EL RANCHO GRANDE I, UNIT 9-B
GRADING & DRAINAGE PLAN
ENGINEER'S CERTIFICATION

DRAINAGE CERTIFICATION

The following minor deviations from the approved plan were noted during inspection:

TITLE: EL RANCHO GRANDE 1, UNIT 9-B
GRADING & DRAINAGE PLAN
ENGINEER'S CERTIFICATION

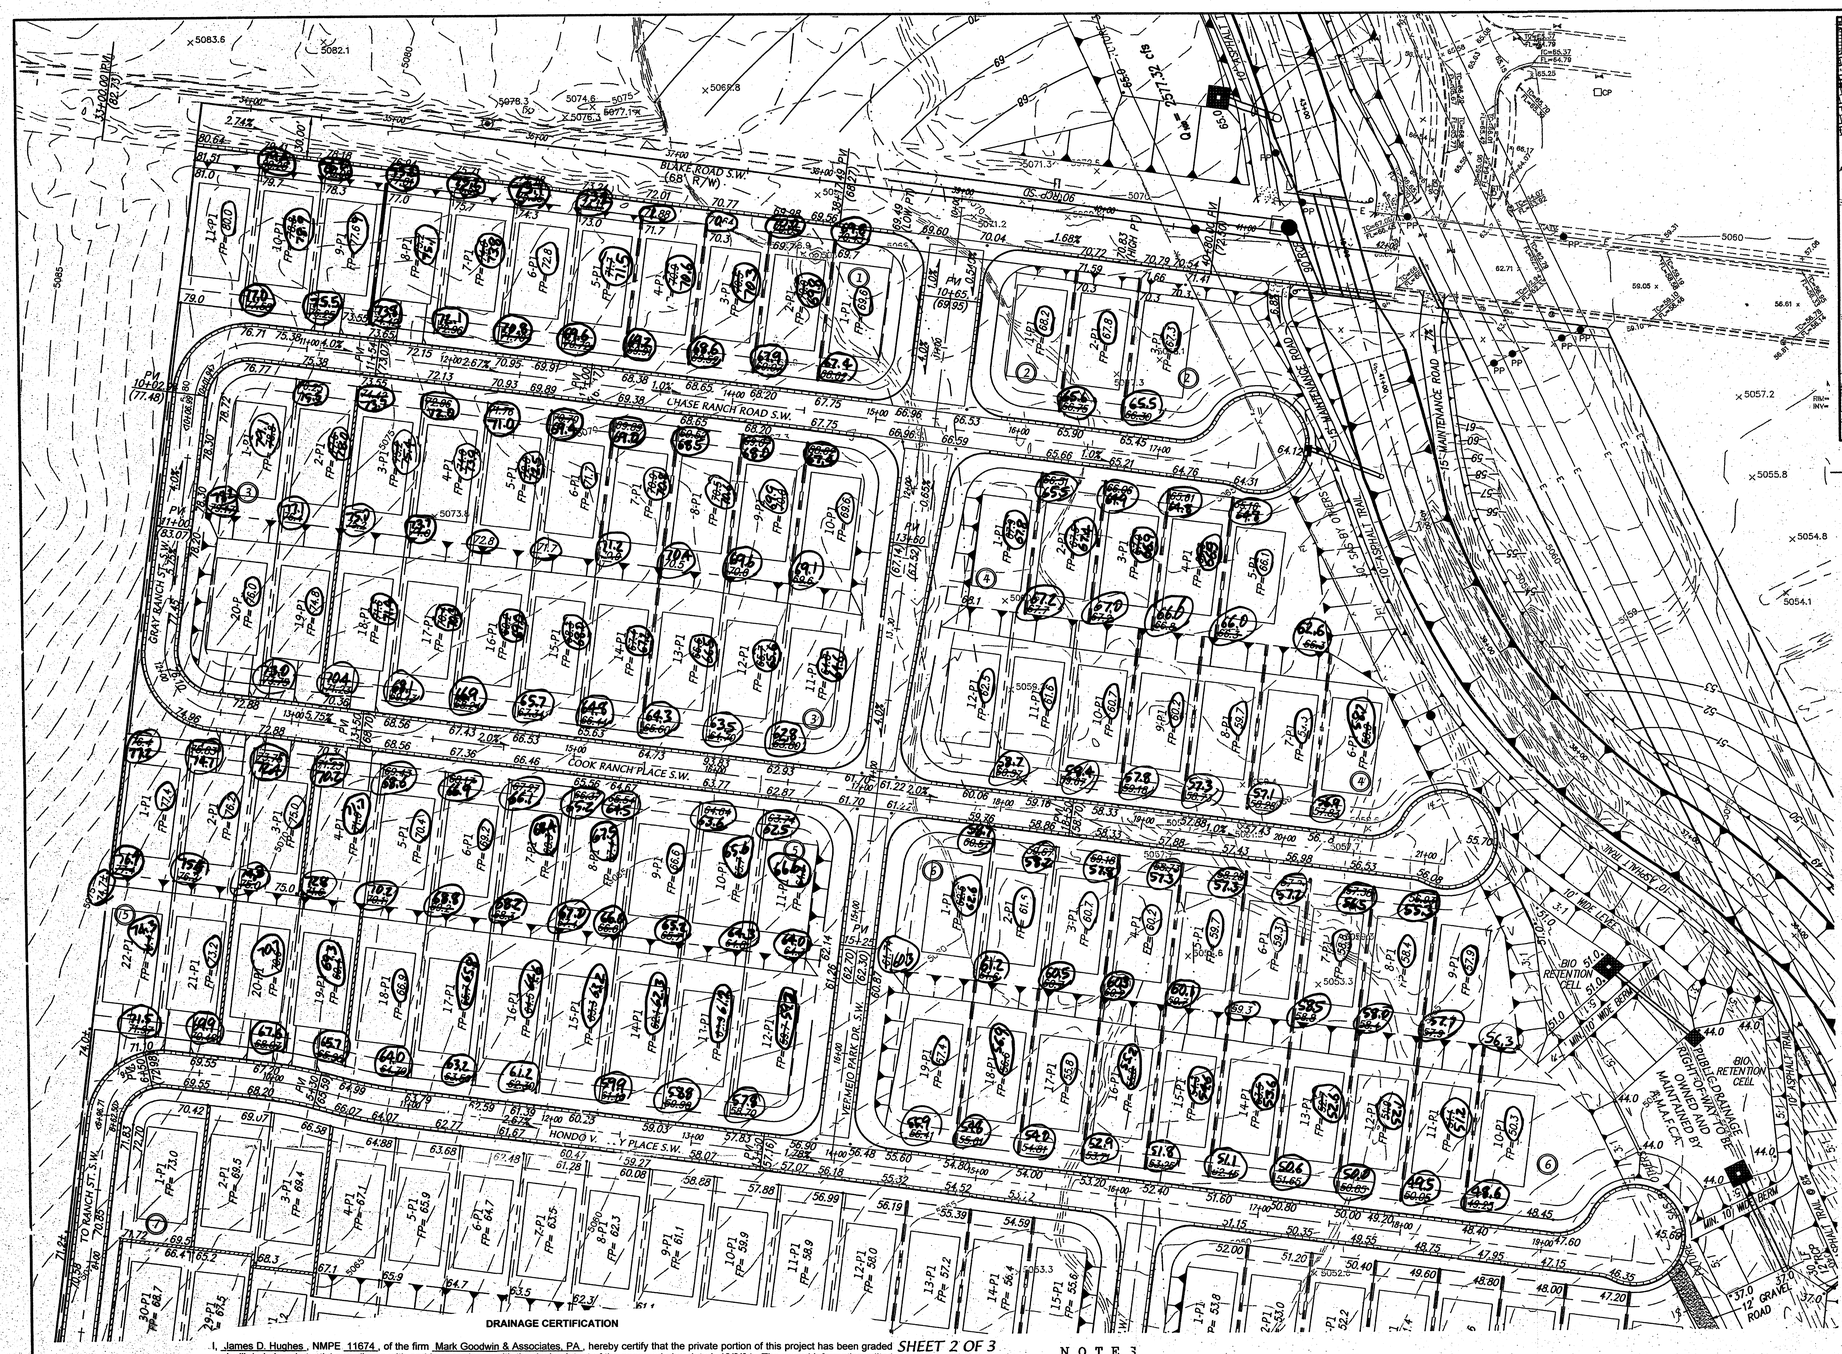
1. *North PL of Amole Mesa is as much as 1.3' higher than planed. All other street / front corners were intentionally left one foot lower than planed as a place for home builders to dispose of footer excavations during house construction. The survey of the west end of Amole Mesa is 3' lower than planned, but it has apparently been regarding since the survey.*

2. *The rear corners of Lots 1 & 2 Block 5, Lot 5 Block 4, and Lot 8 Block 8 are too low to drain to street.*
3. *Pads on lots 12 & 13 Block 5 are 0.5' lower and 0.3 higher than planned making pad to pad change of 2.0'.*

4. *Side yard walls are not built to the street right of way as planned, so cross lot drainage is possible particularly to Lot 20 Block 5, Lot 2 Block 7, Lot 28 Block 7, Lot 22 Block 10,and Lot 3 Block11. The builders will need to make special provisions to prevent cross lot drainage and to get the drainage from the high side lot around the dry utility pedestals and to the street on the above mentioned lots. The lots can easily be made to drain to the street on the other lots where the side yard retaining wall ends short of the street right of way.*

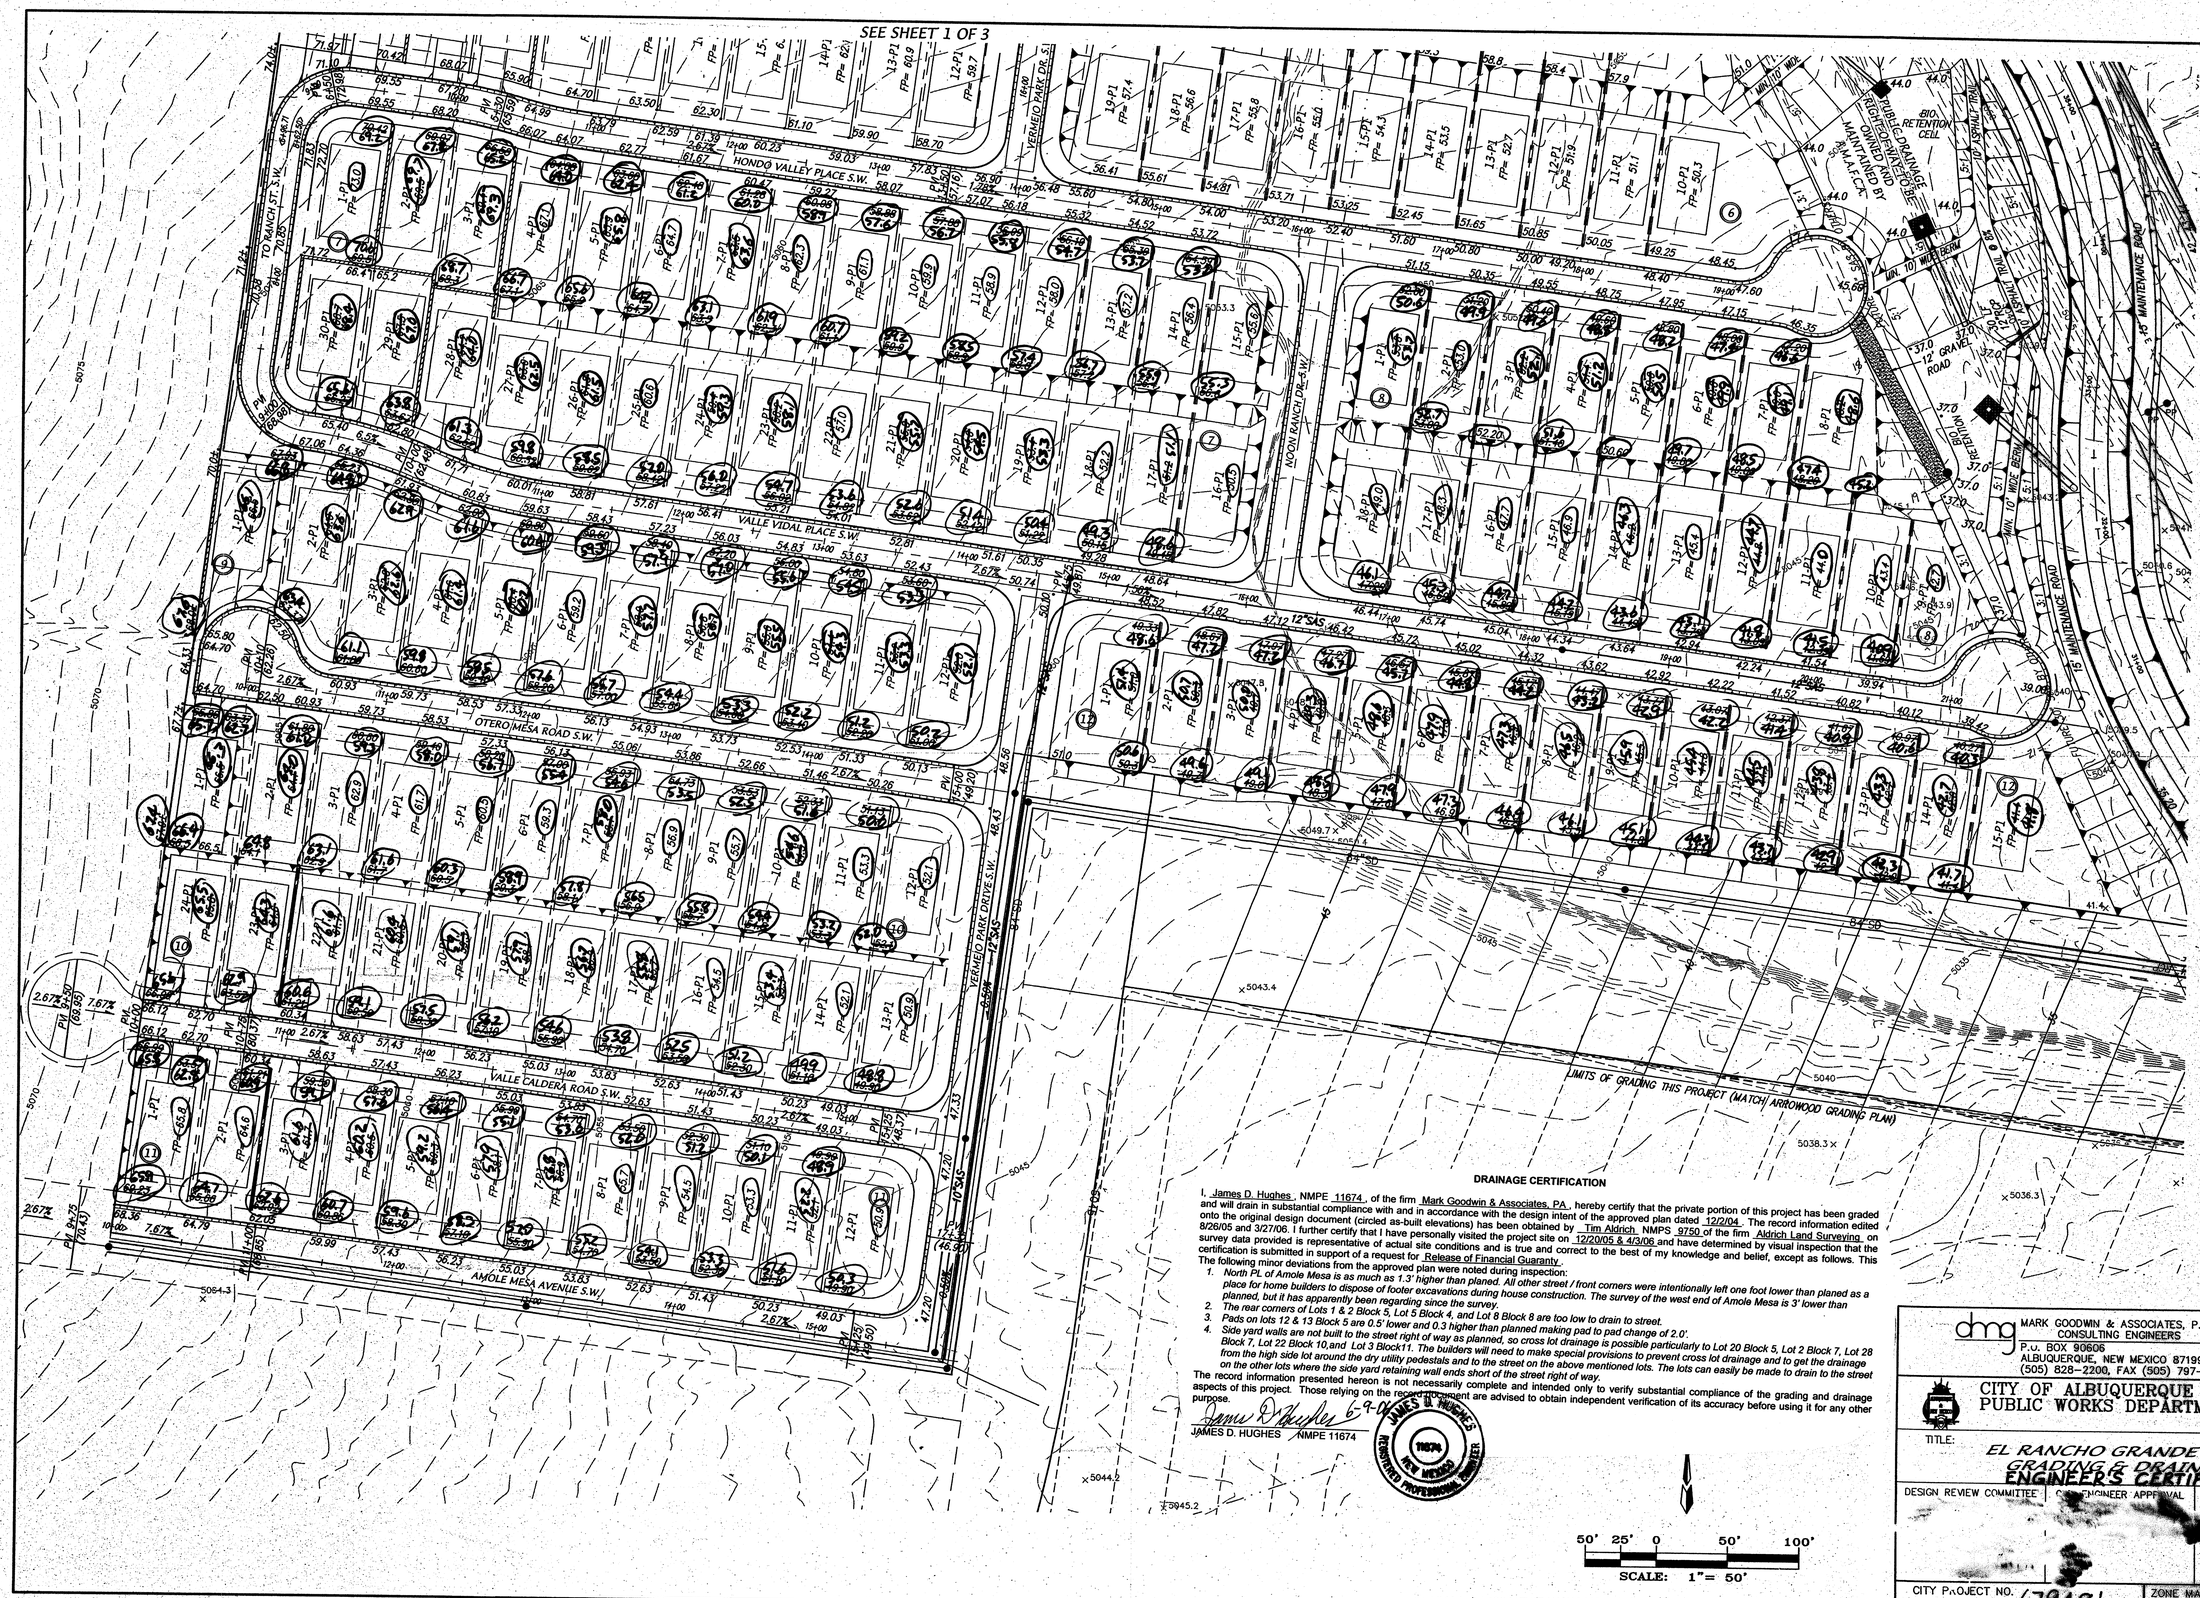
The following minor deviations from the approved plan were noted during inspection:

1. *North PL of Amole Mesa is as much as 1.3' higher than planed. All other street / front corners were intentionally left one foot lower than planed as a place for home builders to dispose of footer excavations during house construction. The survey of the west end of Amole Mesa is 3' lower than planned, but it has apparently been regarding since the survey.*

2. *The rear corners of Lots 1 & 2 Block 5, Lot 5 Block 4, and Lot 8 Block 8 are too low to drain to street.*
3. *Pads on lots 12 & 13 Block 5 are 0.5' lower and 0.3 higher than planned making pad to pad change of 2.0'.*

4. *Side yard walls are not built to the street right of way as planned, so cross lot drainage is possible particularly to Lot 20 Block 5, Lot 2 Block 7, Lot 28 Block 7, Lot 22 Block 10,and Lot 3 Block11. The builders will need to make special provisions to prevent cross lot drainage and to get the drainage from the high side lot around the dry utility pedestals and to the street on the above mentioned lots. The lots can easily be made to drain to the street on the other lots where the side yard retaining wall ends short of the street right of way.*

EL RANCHO GRANDE 1, UNIT 9-B
GRADING & DRAINAGE PLAN
ENGINEER'S CERTIFICATION

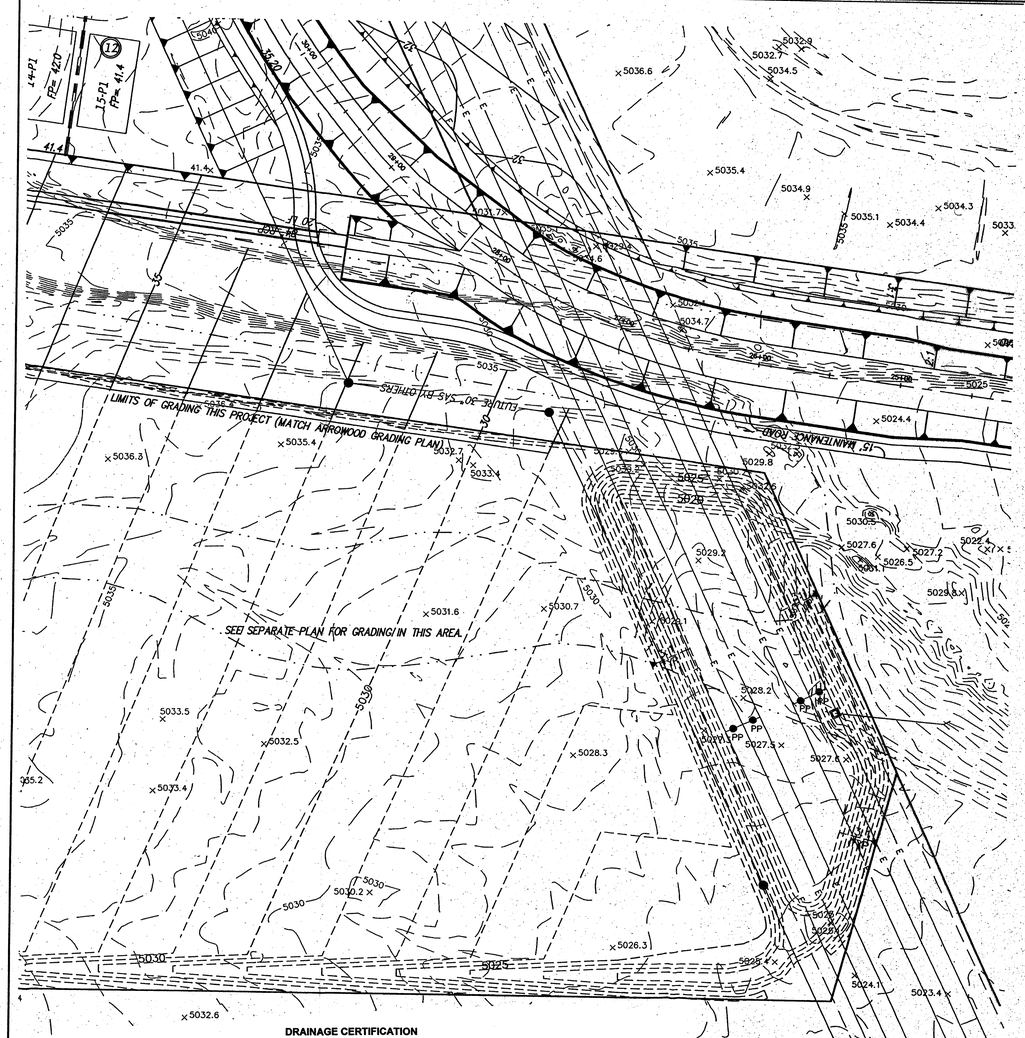
The following minor deviations from the approved plan were noted during inspection:

1. *North PL of Amole Mesa is as much as 1.3' higher than planed. All other street / front corners were intentionally left one foot lower than planed as a place for home builders to dispose of footer excavations during house construction. The survey of the west end of Amole Mesa is 3' lower than planned, but it has apparently been regarding since the survey.*

2. *The rear corners of Lots 1 & 2 Block 5, Lot 5 Block 4, and Lot 8 Block 8 are too low to drain to street.*
3. *Pads on lots 12 & 13 Block 5 are 0.5' lower and 0.3 higher than planned making pad to pad change of 2.0'.*

4. *Side yard walls are not built to the street right of way as planned, so cross lot drainage is possible particularly to Lot 20 Block 5, Lot 2 Block 7, Lot 28 Block 7, Lot 22 Block 10,and Lot 3 Block11. The builders will need to make special provisions to prevent cross lot drainage and to get the drainage from the high side lot around the dry utility pedestals and to the street on the above mentioned lots. The lots can easily be made to drain to the street on the other lots where the side yard retaining wall ends short of the street right of way.*
